08V-283
(9 Pages)

Safety Defect and Noncompliance Report Guide for Vehicles
PART 573 Defect and Noncompliance Responsibility and Reports¹

**INSTALLATION WORK INSTRUCTION
FOR MODIFICATION OF FORD
F-SERIES HIGH IDLE CIRCUIT
2008 6.4 LITER ONLY**

Work instruction : W - 168
Status : In Use
Revision Date : 06.16.2008
Written by : Elec. Eng. Disg.
Approved by : MR Committee
Page : 1 of 1

Figure 1

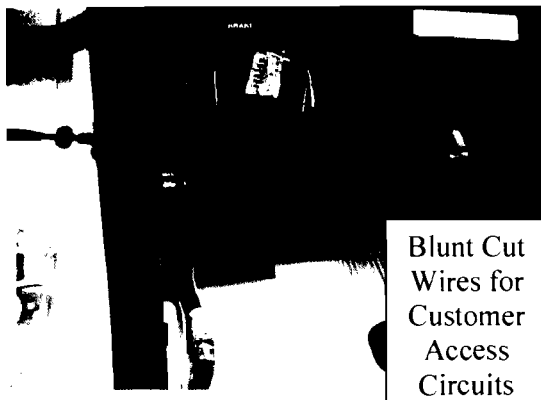
1. Locate the blunt cut wires for customer access circuits. These wires are located under the dash on the driver's side near the park brake. See Figure 1

2. Remove the Y108 wire currently connected to the PTO enable circuit (OEM Yellow/Green blunt cut wire).
3. Connect the Y108 to the input of the high idle relay (relay position 30) using the blue insulated slide terminal provided.

4. Connect the Y537 wire coming from the output of the high idle relay (relay position 87) to the PTO enable circuit (OEM Yellow/Green blunt cut wire) using the blue barrel provided.

5. Connect the Y560 wire coming from the ground side of the high idle relay coil (relay position 85) to the park brake switch output wire (OEM White/Violet). Solder and tape this connection.

6. Connect the Y119 wire coming from the +12 volt side of the high idle relay coil (relay position 86) to the Y119 wire currently connected to the OEM Purple blunt cut wire. Solder and tape this connection.

Figure 2

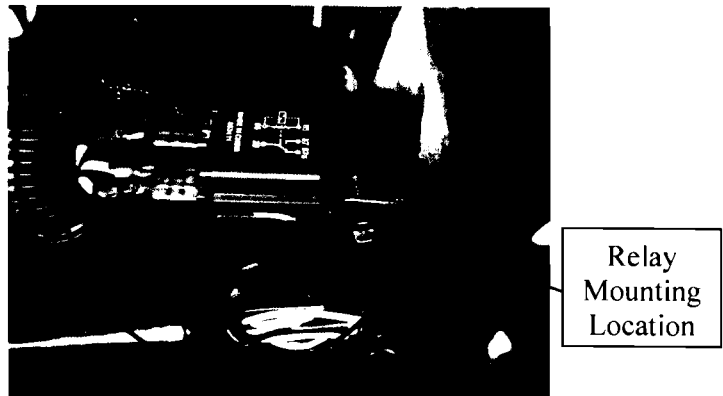
7. Mount the relay by first removing the street side mounting screw for the OBD II connector. Slide the relay mounting bracket between OBD II connector mounting bracket and the dash support bracket as shown in Figure 2. Replace the OBD II connector mounting screw.
